PLANNING COMMISSION MEETING
Monday, May 28, 2026 – 7:00 p.m.
Farmington City Hall
23600 Liberty Street
Farmington, MI 48335

Subject: Vibe Credit Union (Site Plan Review)
Location: 31806 Grand River Ave (parcel ID: 23-27-403-141)
Zoning: C2 Community Commercial
Plan Date: April 24, 2026
Applicant: Hunter Karam

Description Site Plan Review – 33224 Grand River Avenue, Farmington Village Place

A
L1 Site Plan
Plan 1/16"=1'-0"

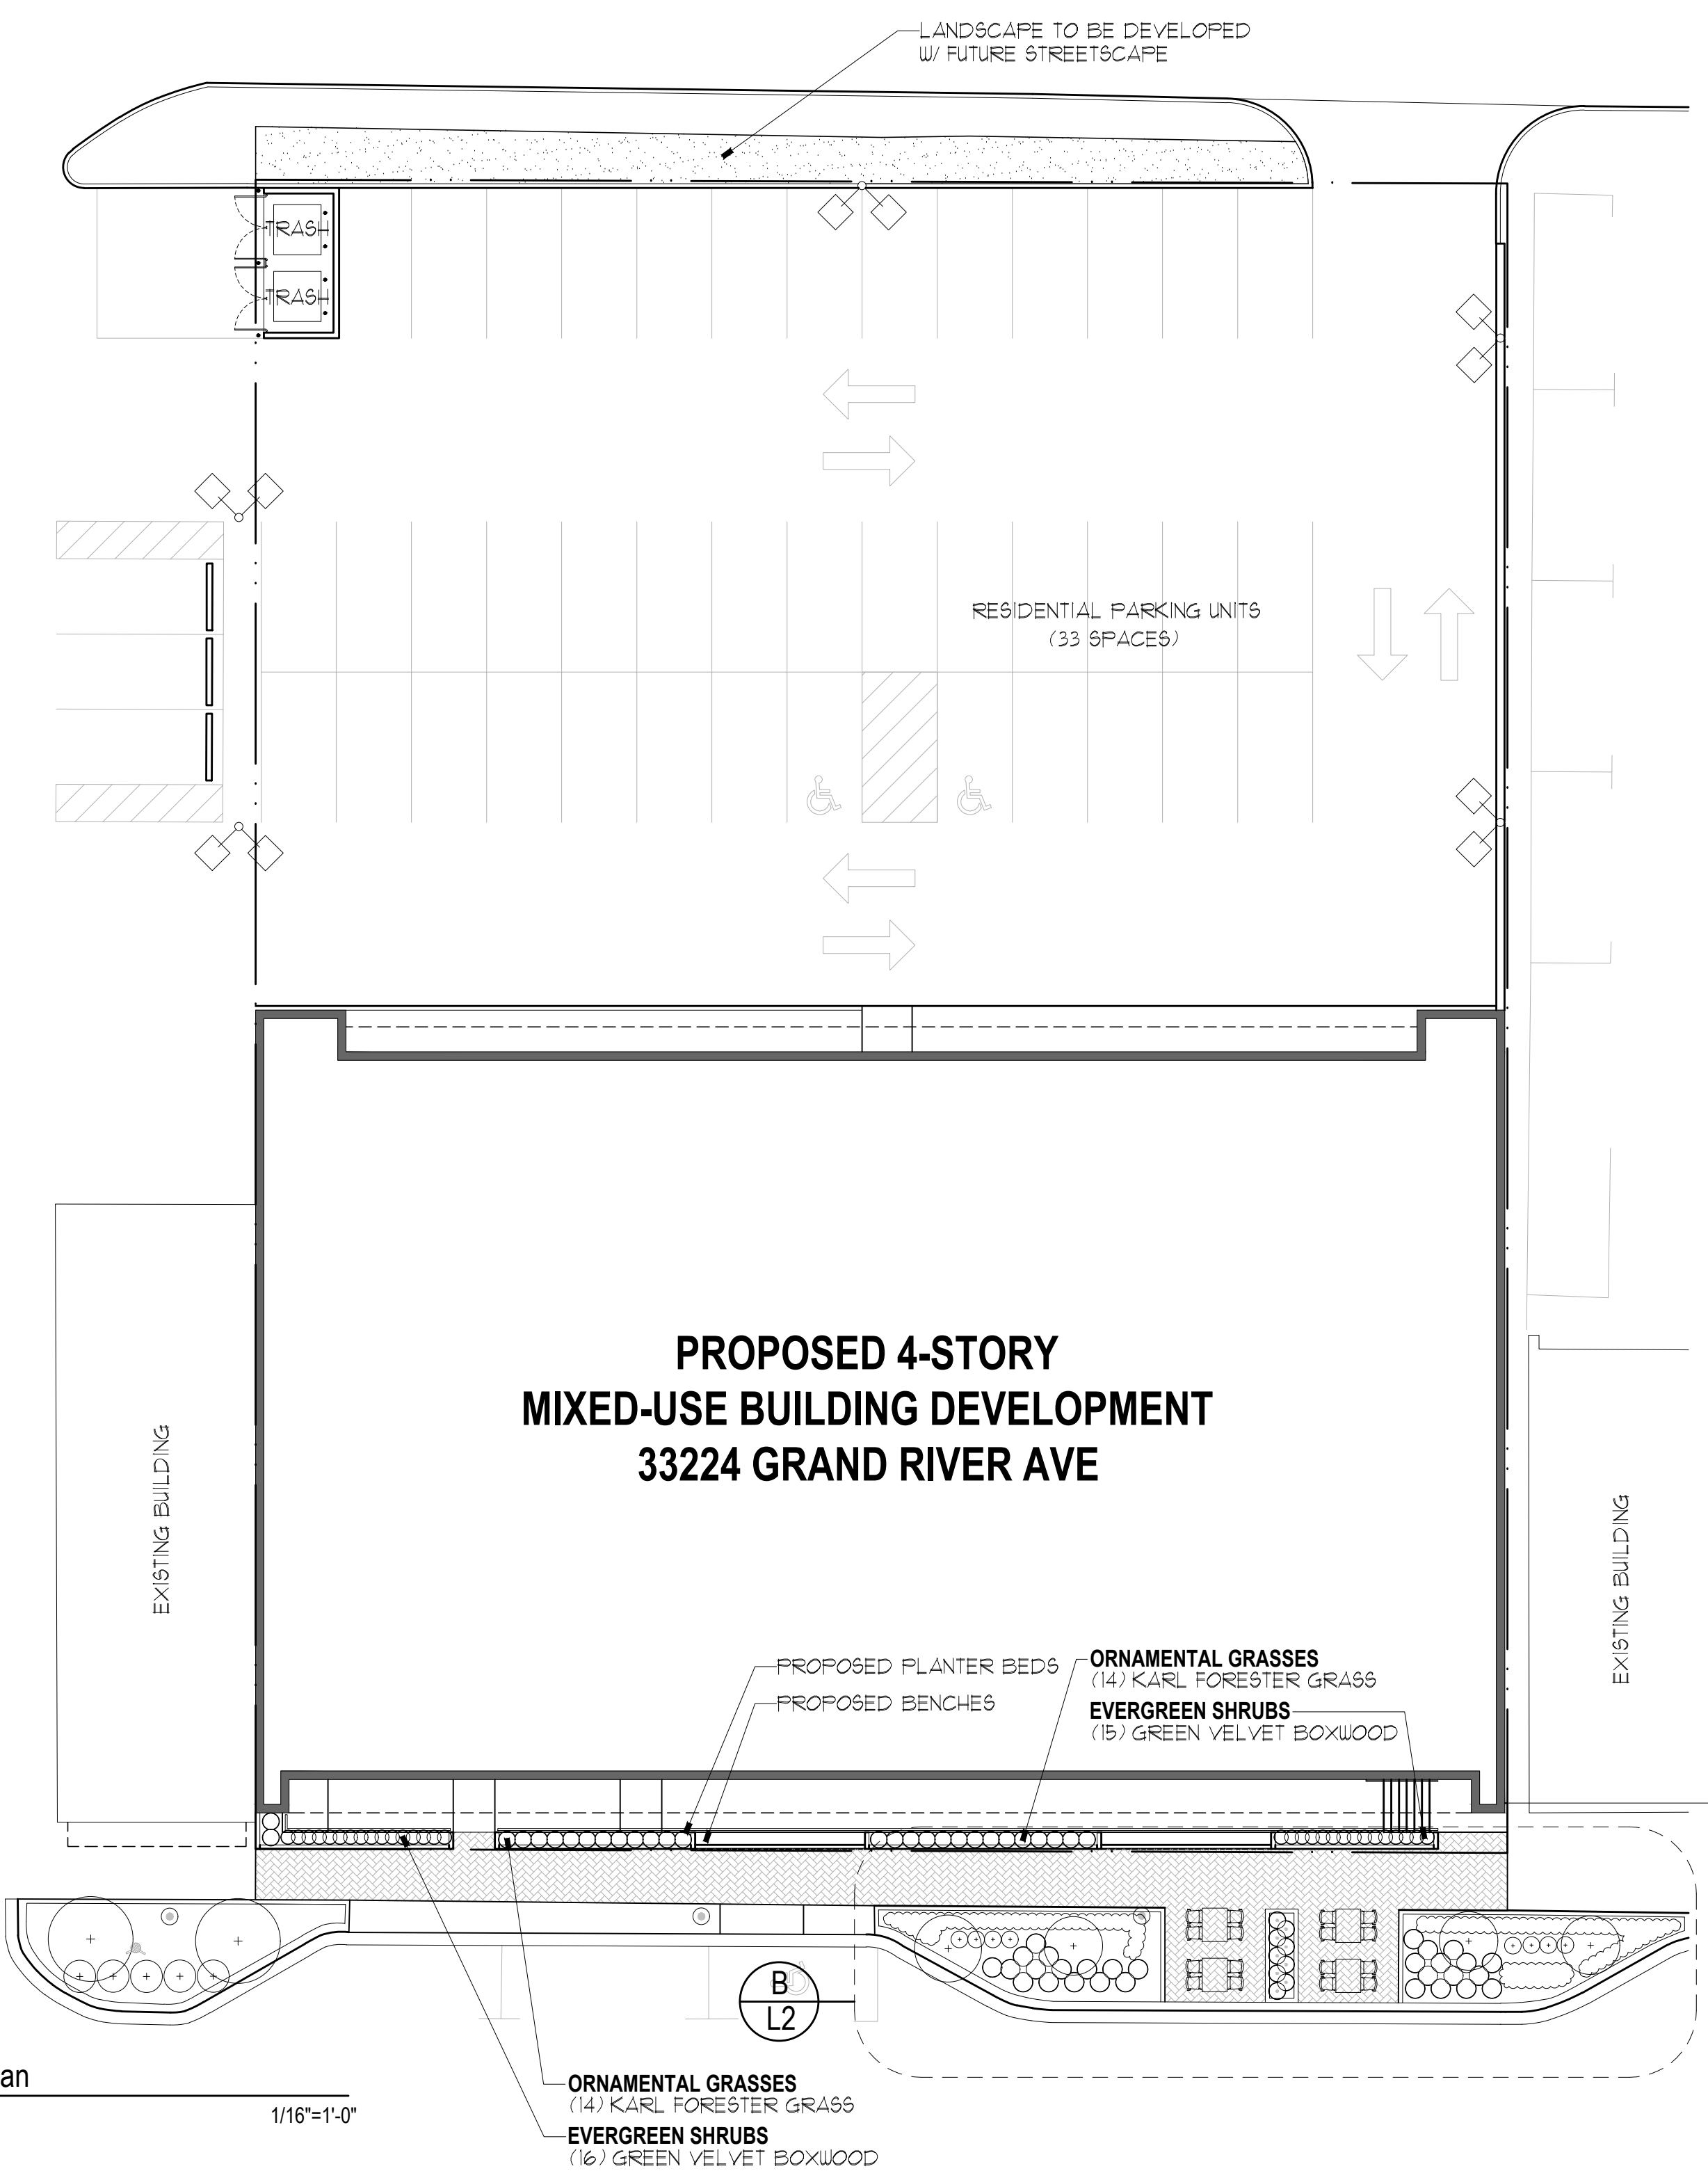
- 13. Installation, Irrigation and Maintenance (§35-184).** All landscaped areas shall be provided with an underground irrigation system. On Sheet L1 the applicant indicated that a new irrigation system will be
